7.6 All Other Instrumentation Systems Required for Safety

The information in this section of the reference ABWR DCD, including all subsections, tables, and figures, is incorporated by reference with the following departures and supplements.

Figure 7.6-4a Basic Configuration of a Typical Neutron Monitoring System Division

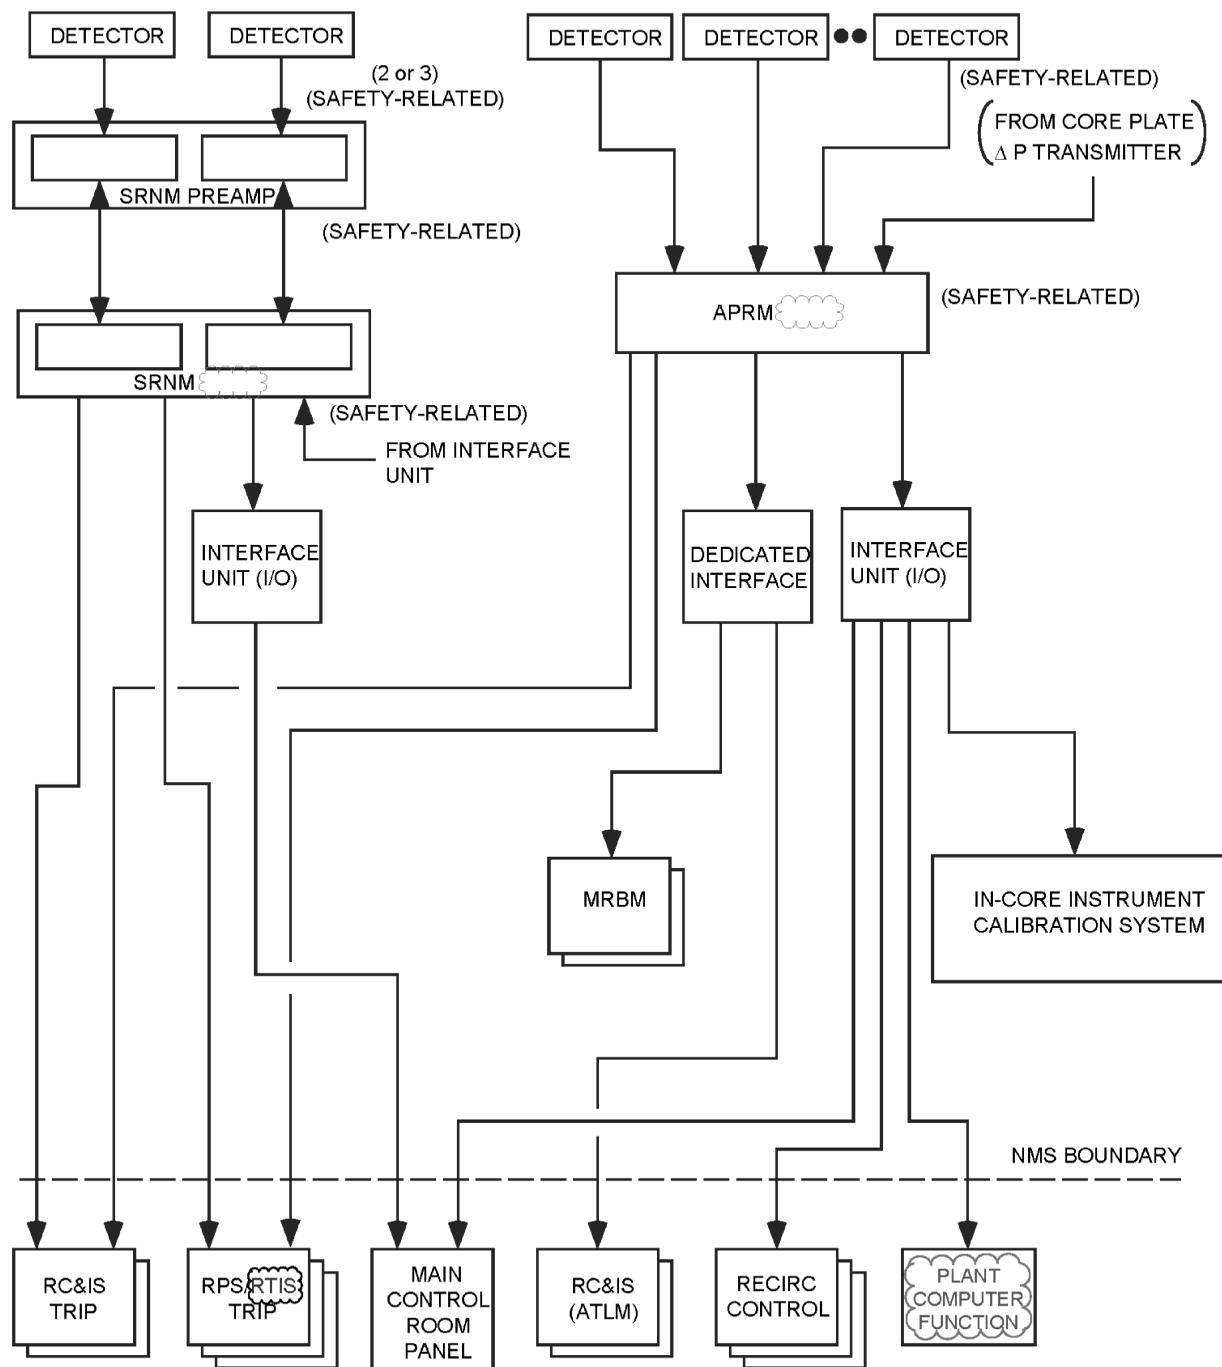
STD DEP T1 3.4-1 (Table 7.6-5 and Figures 7.6-1, 7.6-2, 7.6-4a)

The purpose of the Neutron Monitoring System (NMS) is to monitor power generation and, for the safety function part of the NMS, to provide trip signals to the Reactor Protection System (RPS) to initiate reactor scram under excessive neutron flux (and power) increase condition (high level) or neutron flux fast rising (short period) condition. The NMS also provides power information of operation and control of the reactor to the Plant ~~Process~~ Computer System (PCS) Functions (PCF) and the rod block monitor. A block diagram showing a typical NMS division is shown in Figure 7.6-4a. The operating ranges of the various detectors are shown in Figure 7.6-4b.

Figure 7.6-9 Instrumentation Location Definition for the Suppression Pool Temperature Monitoring System

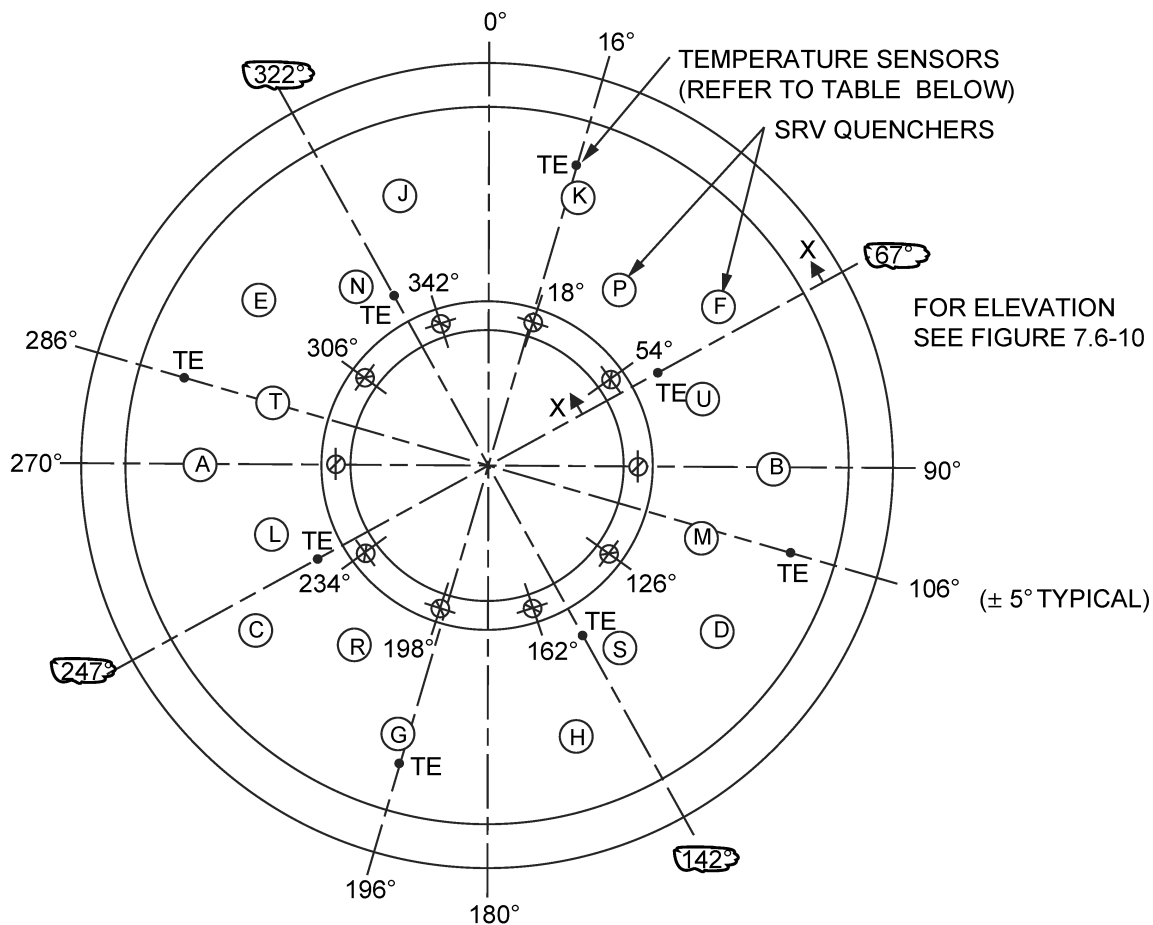
STD DEP 7.6-3 (Figures 7.6-9, 7.6-11)

STD DEP 7.6-3

The SPTM System configuration is shown in Figures 7.6-9 and 7.6-10. There are eight temperature circumferential sensor locations (Figure 7.6-9), which are chosen based upon the following considerations:

Figure 7.6-14 OPRM Logic

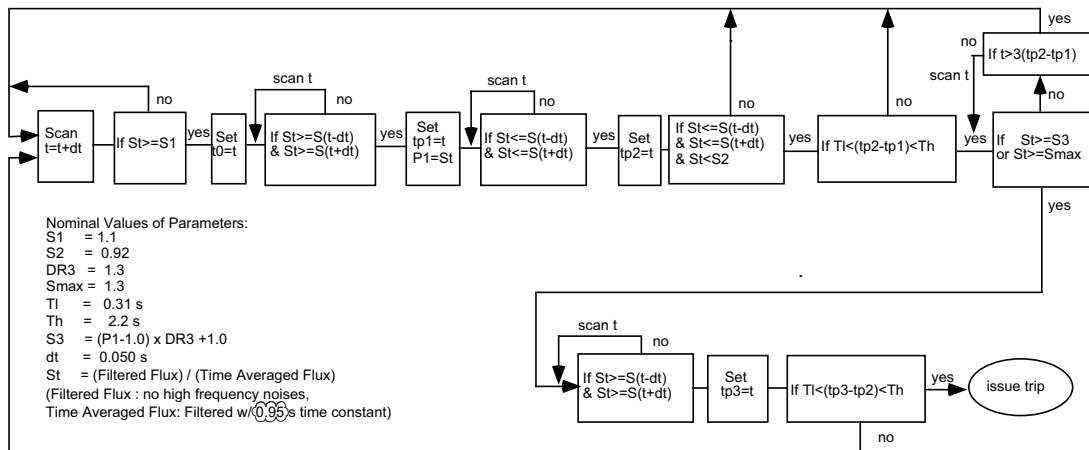
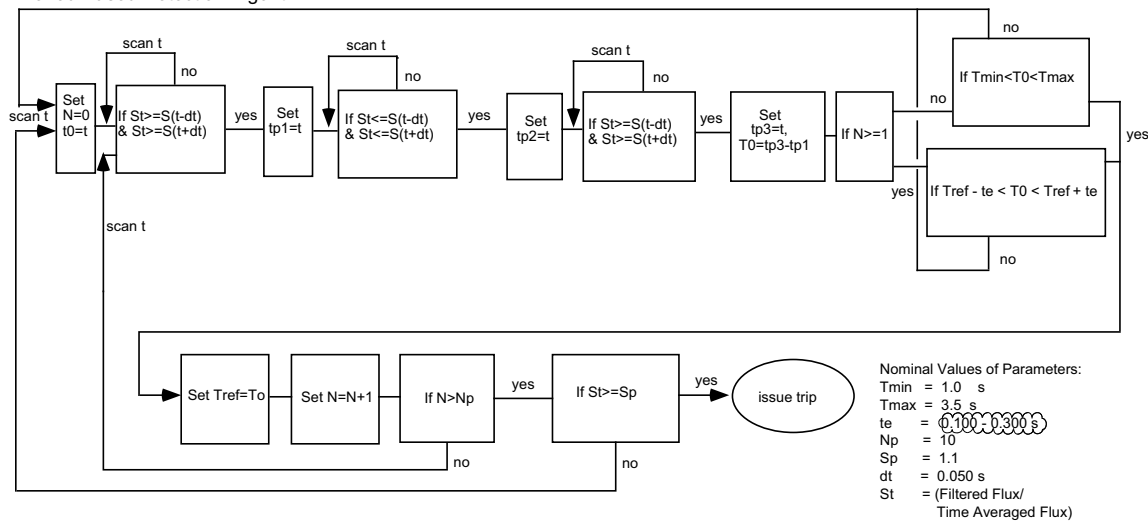
STD DEP 7.6-1 (Table 7.6-2 and Figures 7.6-2, 7.6-14)

For the OPRM trip function, the response signal of any one OPRM cell that satisfies the conditions and criteria of the trip algorithm will cause a trip of the associated OPRM channel. Figure 7.6-14 illustrates the trip algorithm logic. ~~The OPRM trip function does not have its own inoperative trip for insufficient number of total LPRM inputs in the channel. It follows the APRM's inoperative trip of insufficient number of LPRMs.~~ The OPRM function has its own inoperative trip when the channel has less than the required minimum operable cells, when there is an OPRM self-diagnostic fault, when the APRM instrument watchdog timer has timed out, or if there is a loss of power to the APRM instrument.

$T_{\min}=1\text{ s}$, $T_{\max}=3.5\text{ s}$, $\pm t_{\text{error}}=0.15\text{ s}$ **[0.100 - 0.300s]**, $N_P=10$.
 (For details see Figure 7.6-14).
